Architect's Supplemental Instructions

Architect's ASI No: 017

Project:
Webster University
Interdisciplinary Science
Building

Date Issued: 10/17/2016

SHEET E0101.B LEVEL 01 AREA B FLOOR PLAN – ELECTRICAL & AUXILIARY

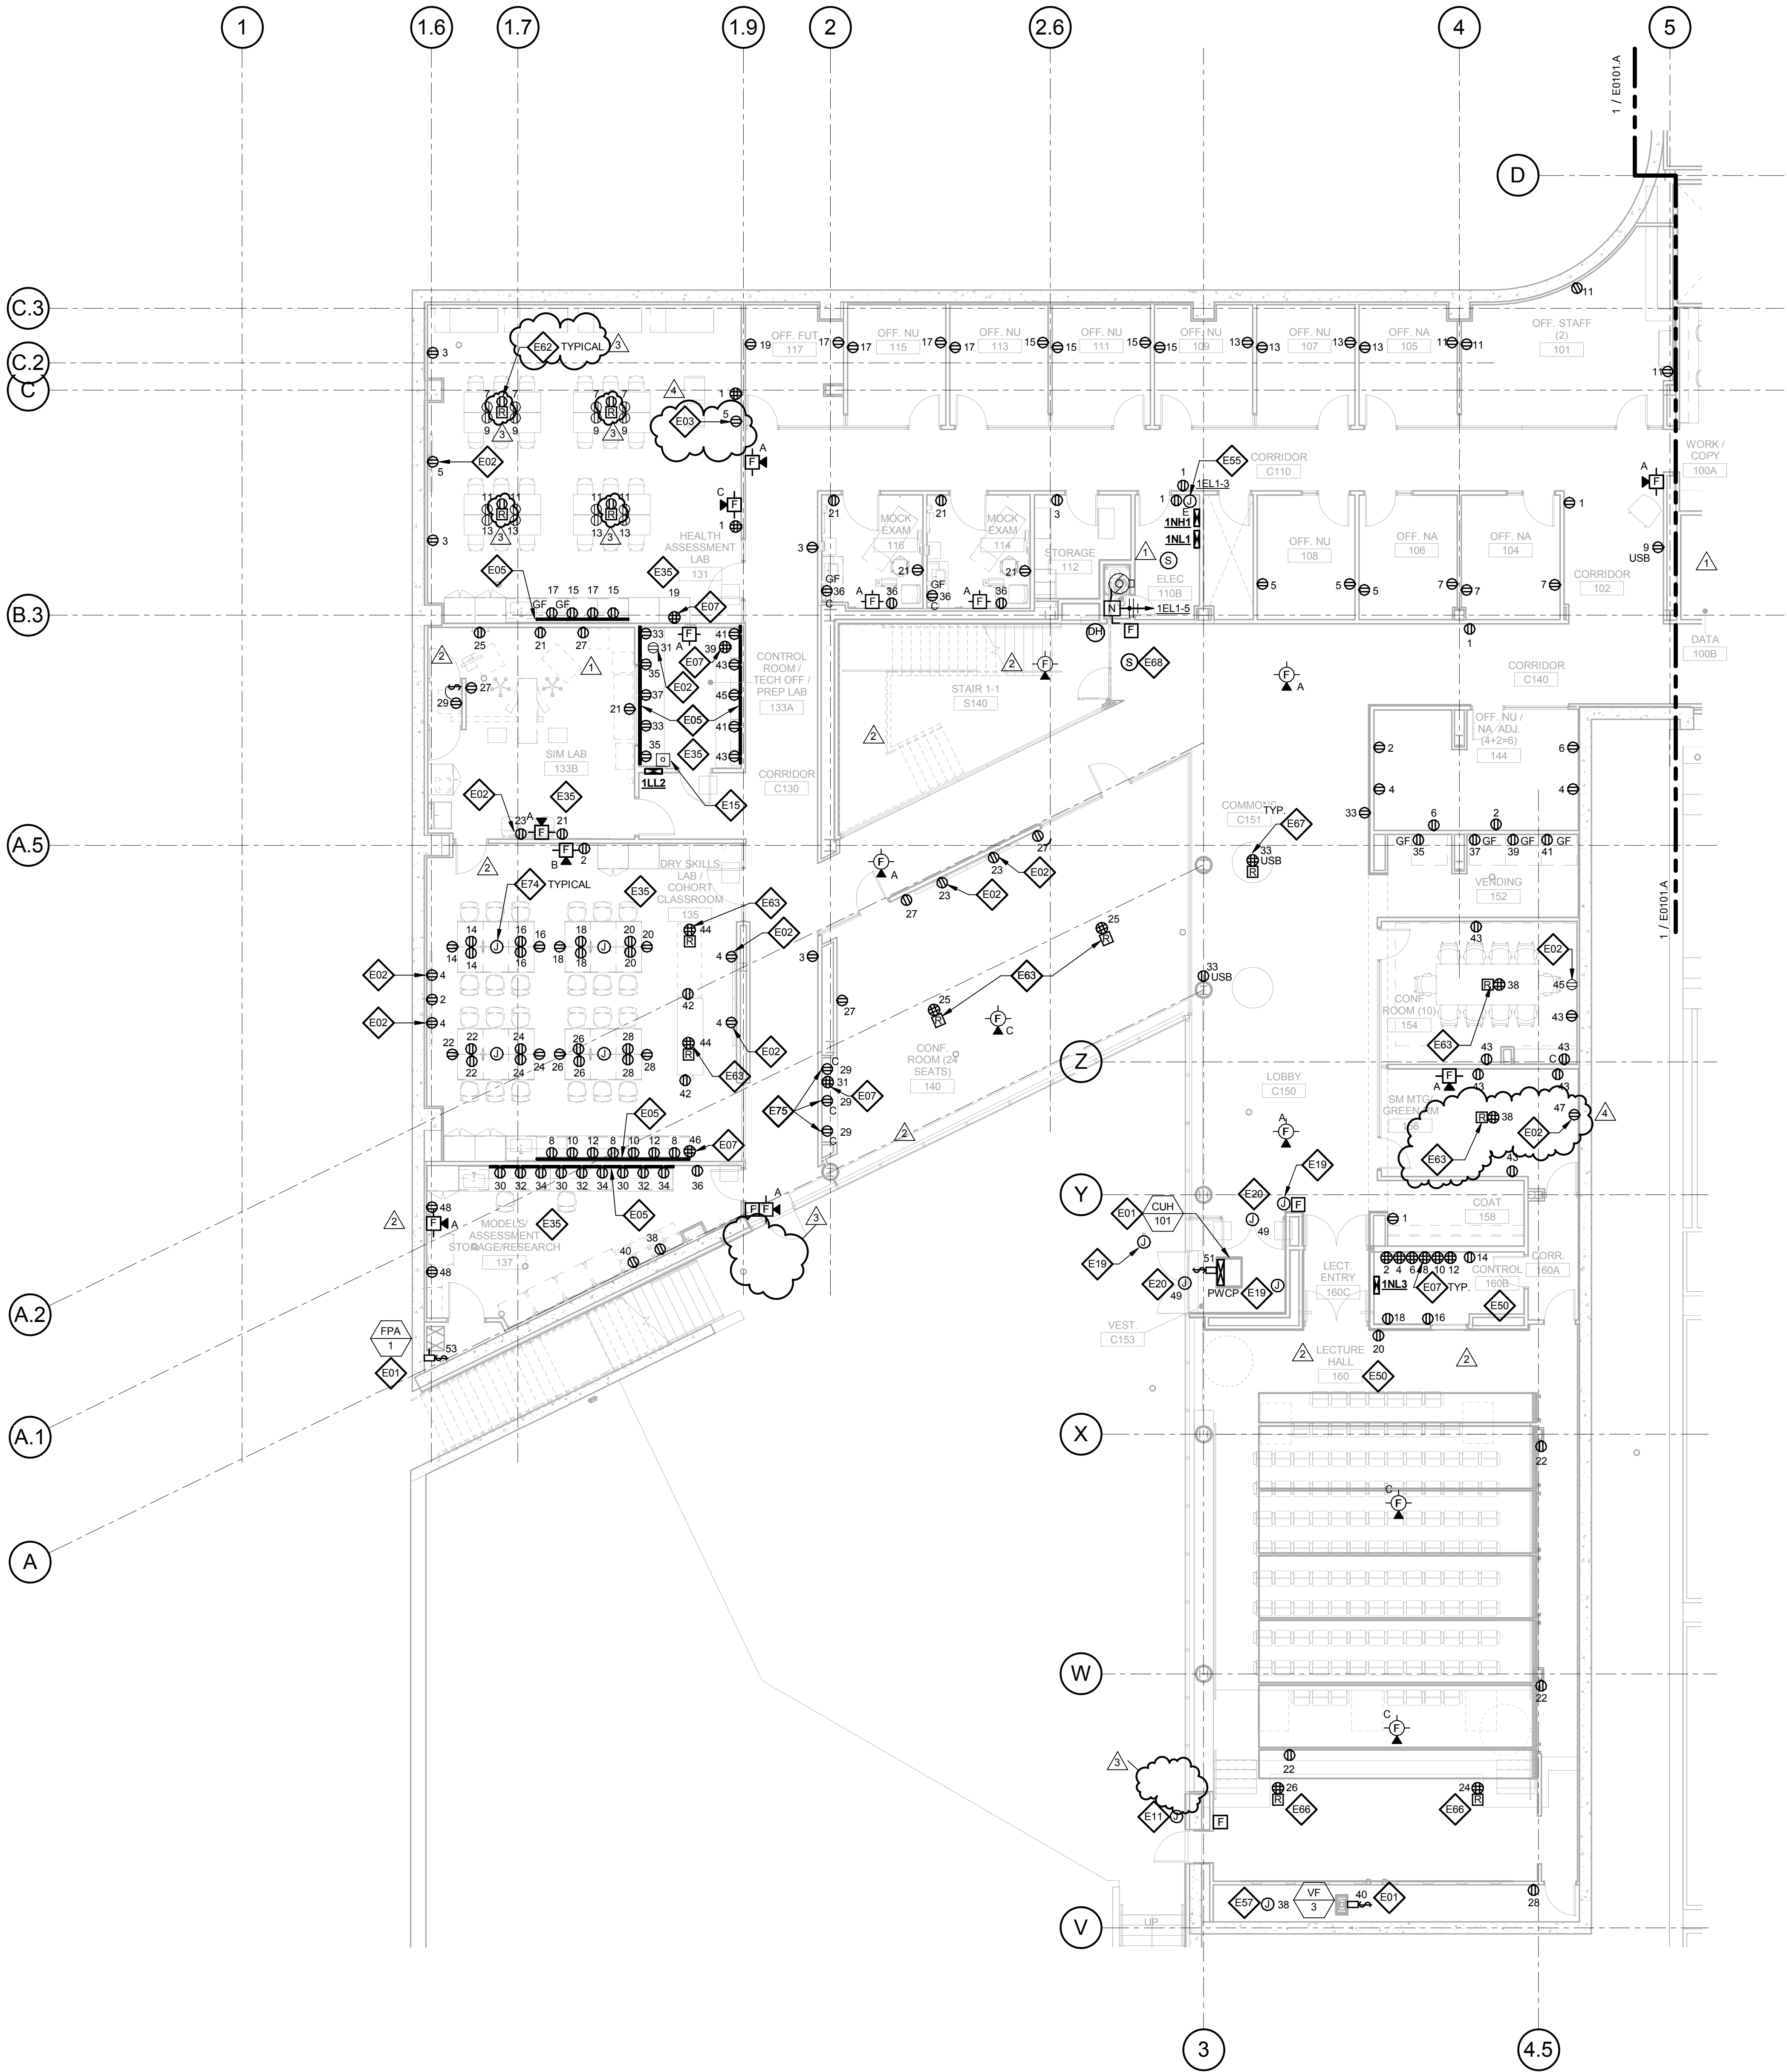
- In courtyard, delete the two outdoor GFCI receptacles and associated circuit 54. Label circuit 54 in panel 1NL1 as spare.
- Revise Keyed Note E62 to replace, “20A TWIST-LOCK RECEPTACLES, NEMA L5-20R” with “20A STANDARD DUPLEX RECEPTACLES, NEMA 5-20R”.
- Revise associated floor box symbols to indicate a standard duplex receptacle in-lieu of a special receptacle.

SHEET E0102.A LEVEL 02 AREA A FLOOR PLAN – ELECTRICAL & AUXILIARY

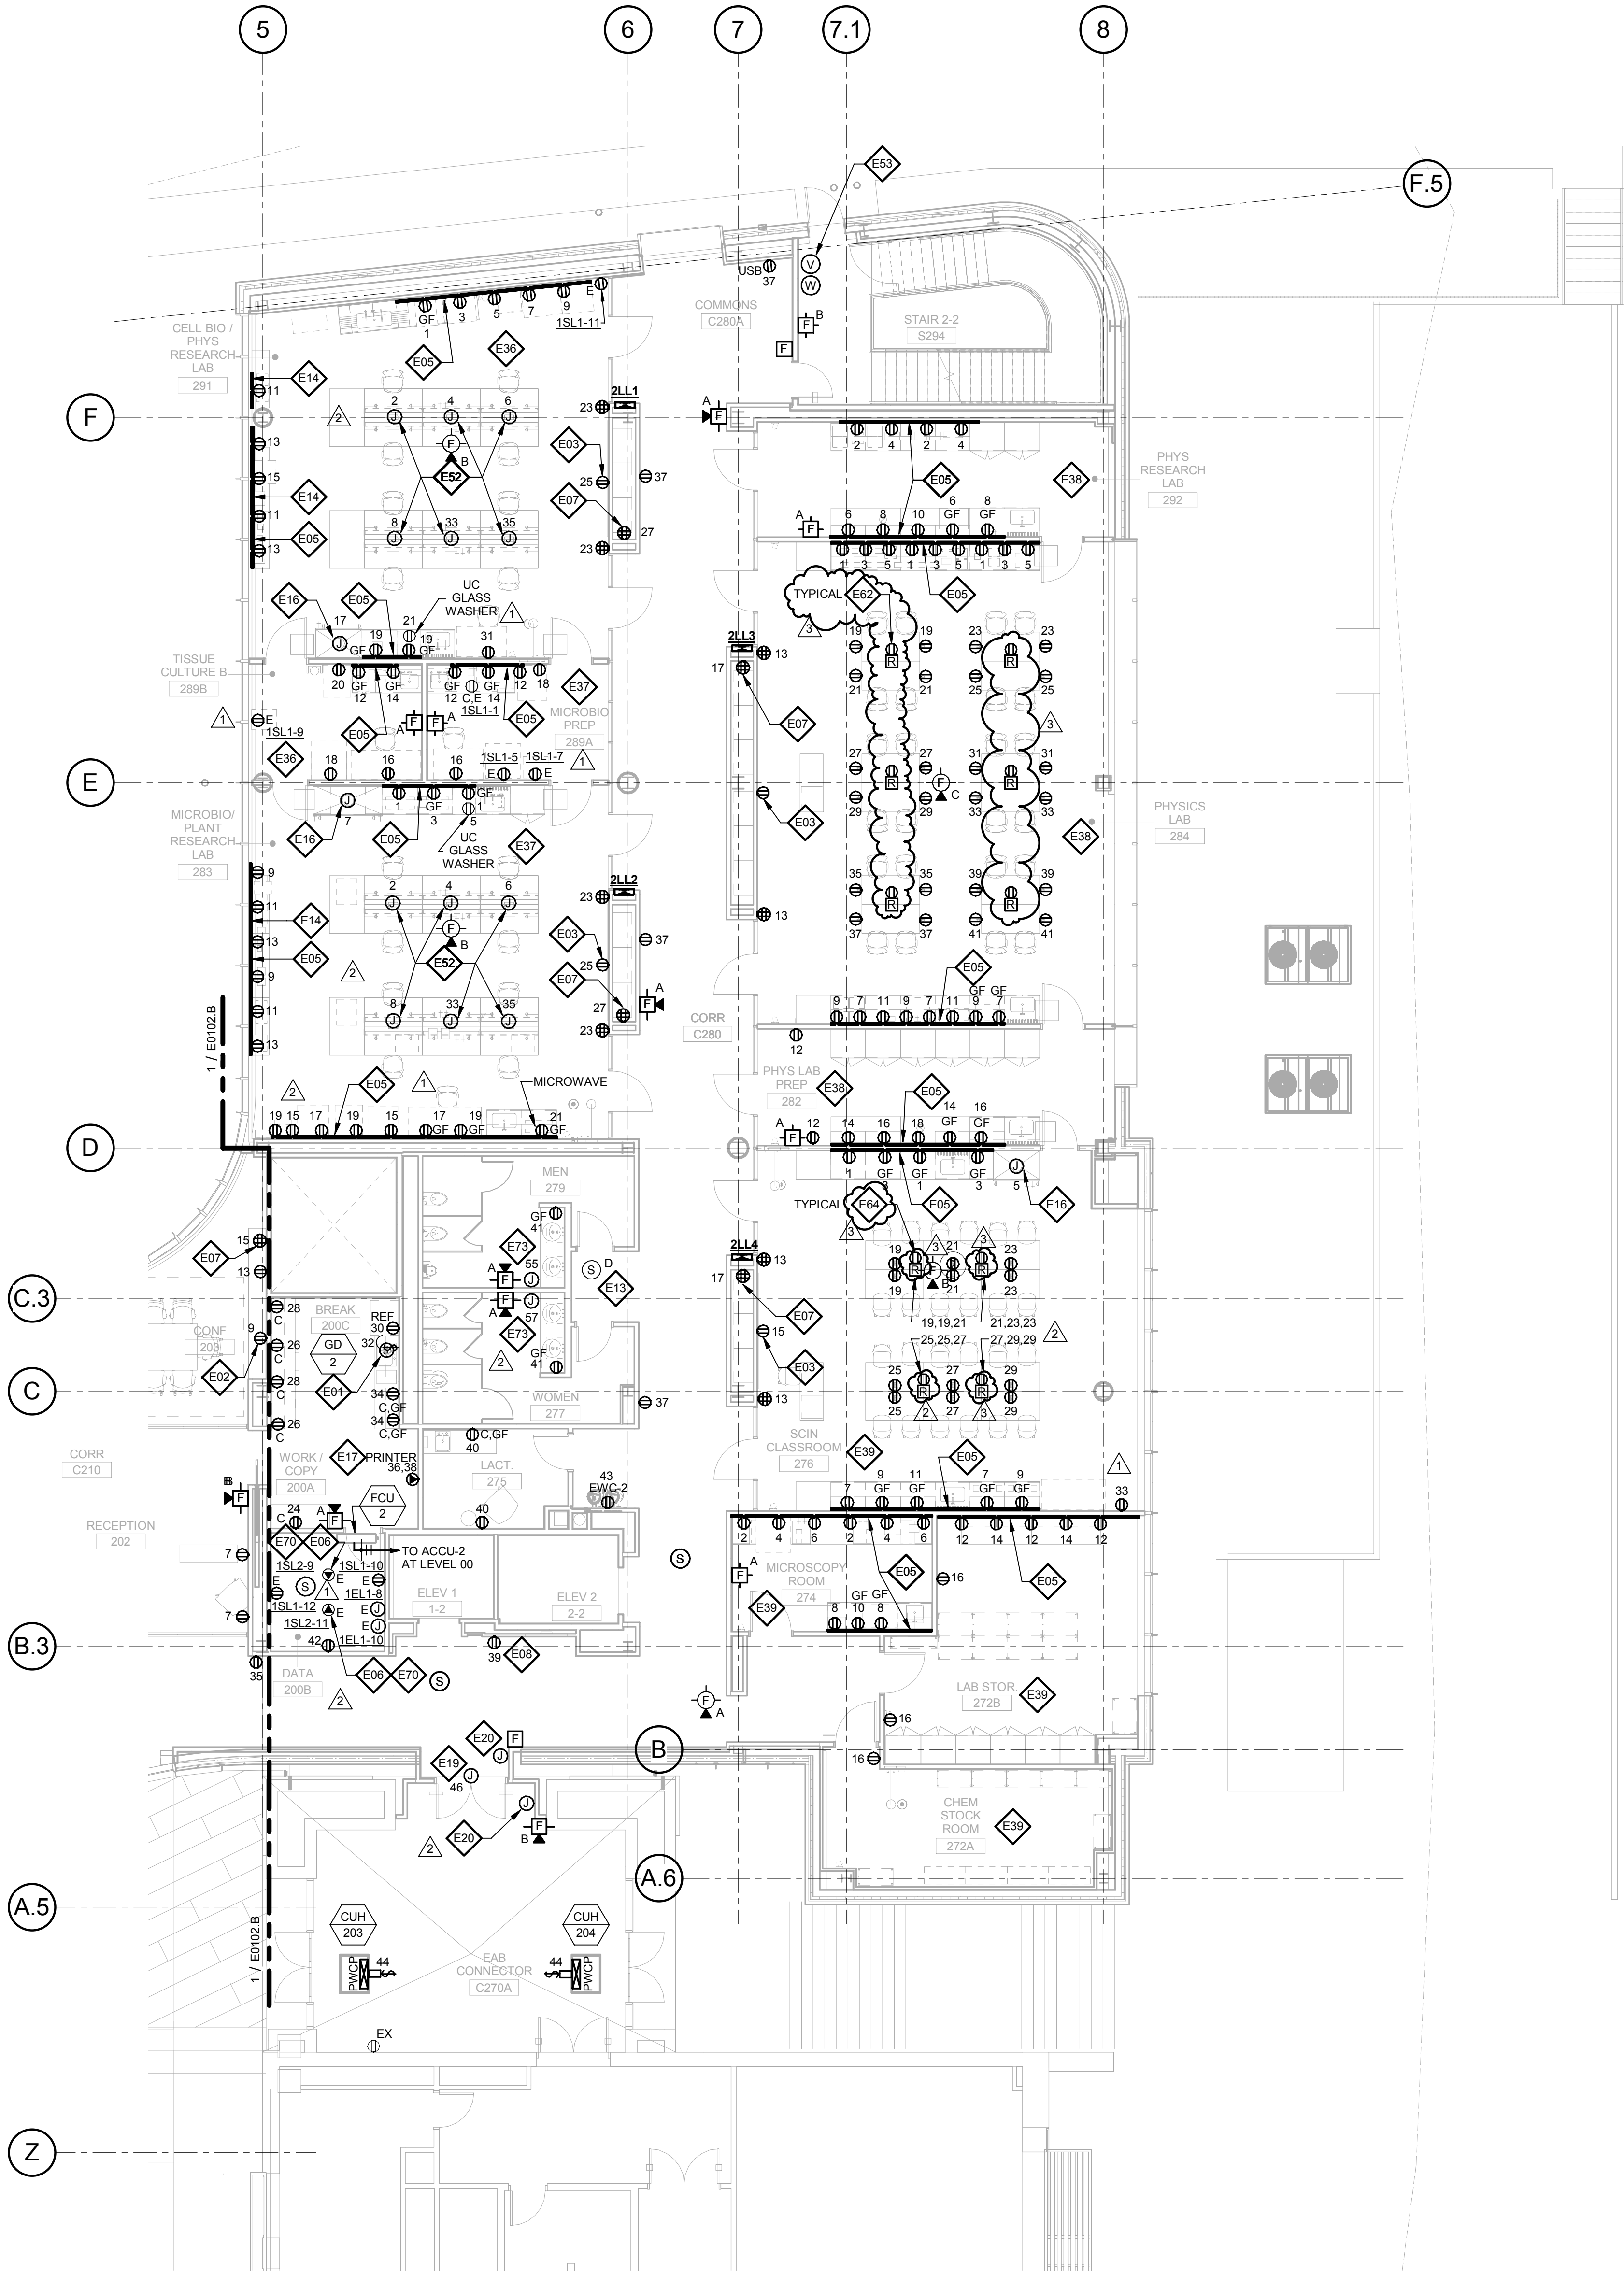
- Revise Keyed Note E62 to replace, “20A TWIST-LOCK RECEPTACLES, NEMA L5-20R” with “20A STANDARD DUPLEX RECEPTACLES, NEMA 5-20R”.
- Revise Keyed Note E64 to replace, “20A TWIST-LOCK RECEPTACLES, NEMA L5-20R” with “20A STANDARD DUPLEX RECEPTACLES, NEMA 5-20R”.
- Revise associated floor box symbols to indicate a standard duplex receptacle in-lieu of a special receptacle.

SHEET E0102.B LEVEL 02 AREA B FLOOR PLAN – ELECTRICAL & AUXILIARY

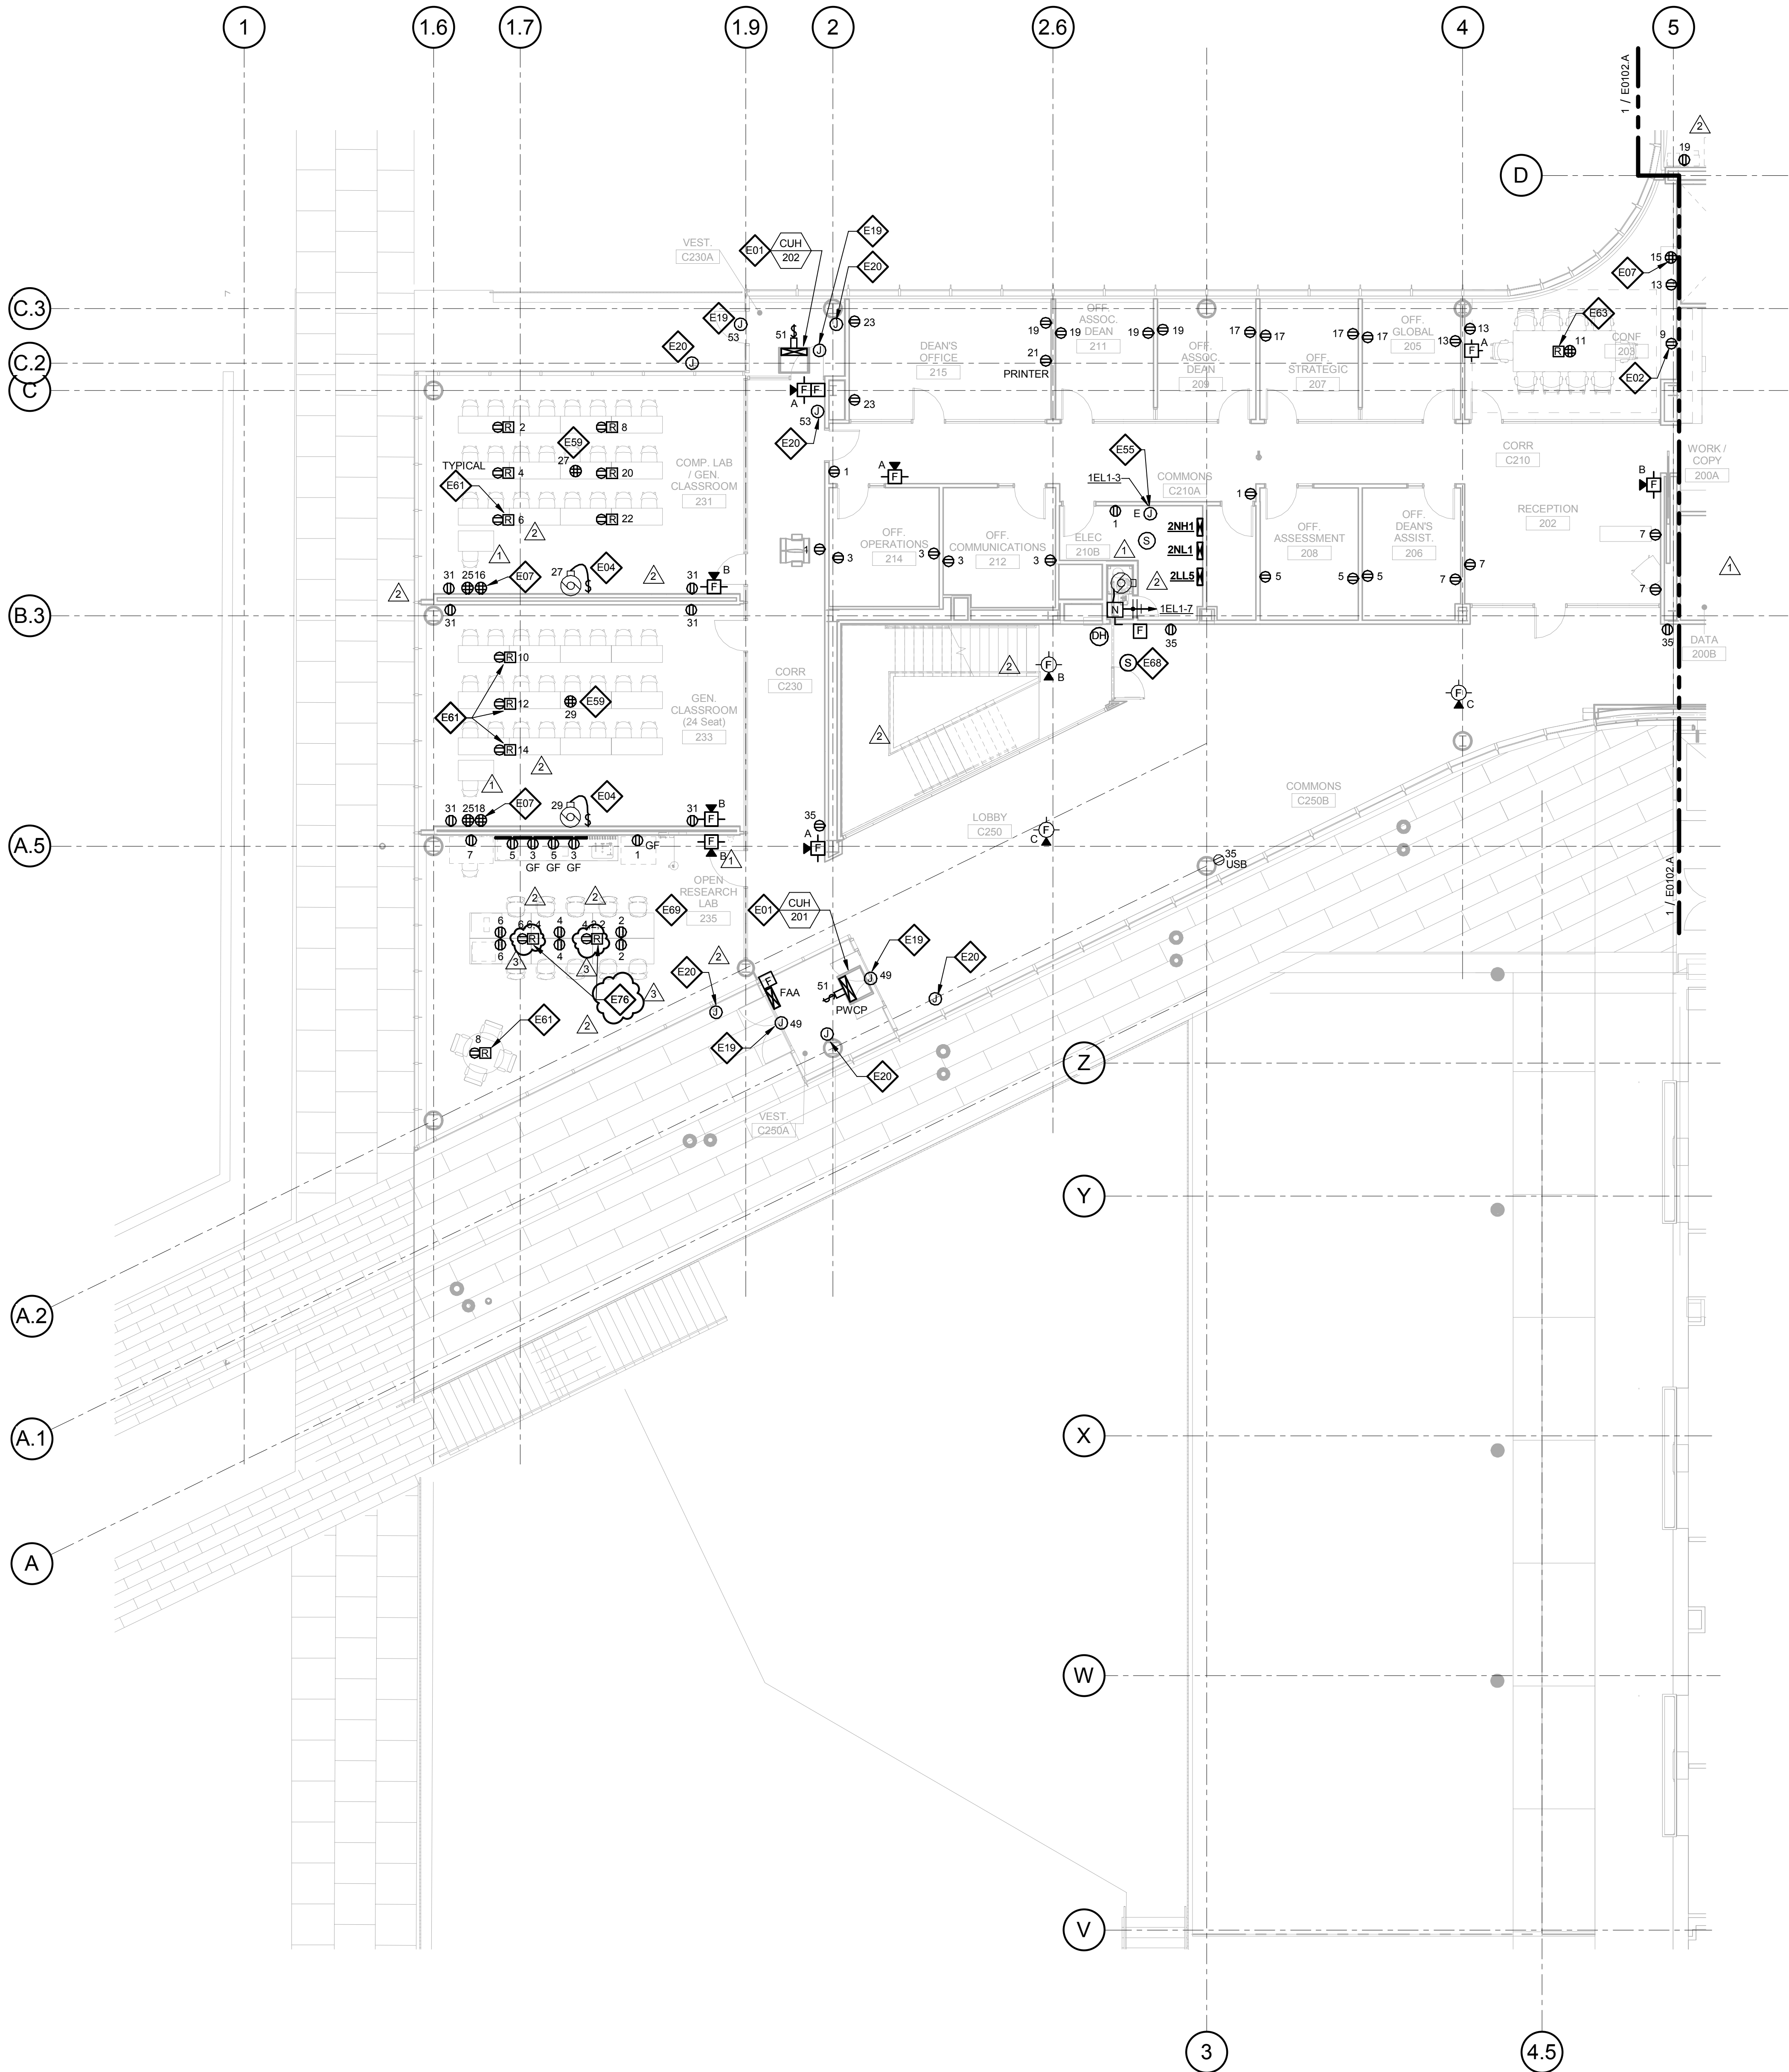
- Revise Keyed Note E76 to replace, “20A TWIST-LOCK RECEPTACLES, NEMA L5-20R” with “20A STANDARD DUPLEX RECEPTACLES, NEMA 5-20R”.
- Revise associated floor box symbols to indicate a standard duplex receptacle in-lieu of a special receptacle.
